UNITED STATES NUCLEAR REGULATORY COMMISSION

PHILADELPHIA ELECTRIC COMPANY

Docket No. 50-278

APPLICATION FOR AMENDMENT
OF
FACILITY OPERATING LICENSE
DPR-56

Figure 3.5.1.1.H Maximum Average Planar Linear Heat Generation Rate
Versus Planar Average Exposure

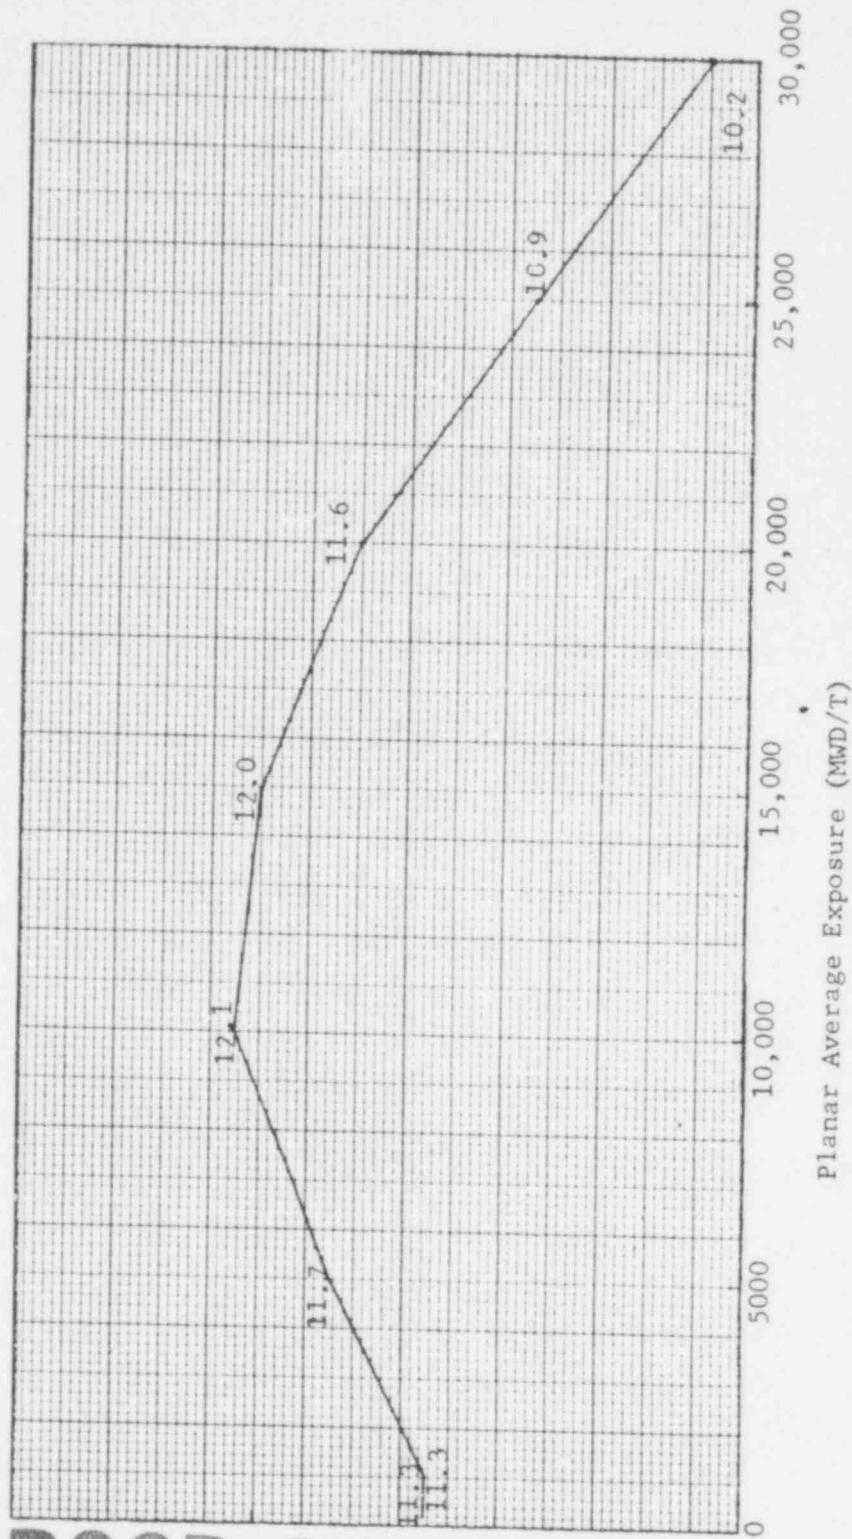
Philadelphia Electric Company, Licensee under Facility Operating License DPR-56 for Peach Bottom Atomic Power Station Unit No. 3, hereby requests that the Technical Specifications incorporated in Appendix A of the Operating License be amended by deleting pages 15a and 15b, by revising certain sections as indicated by a vertical bar in the margin of attached pages iv, v, 1, 3, 7, 10, 11, 14, 15, 18, 19, 20, 33, 35, 37, 40, 54, 73, 74, 108, 111, 115, 119, 120, 122, 133a, 133c, 138, 140, 140a, 140c, 140d, 140e, 144, 152a, 157, and 241, and by adding page 142g.

The proposed amendment would permit the loading of the prepressurized retrofit 8X8 fuel design. A safety evaluation for use of the prepressurized retrofit 8X8 fuel, previously approved by the Nuclear Regulatory Commission is provided by General Electric document NEDE-24011-P-A, August, 1978
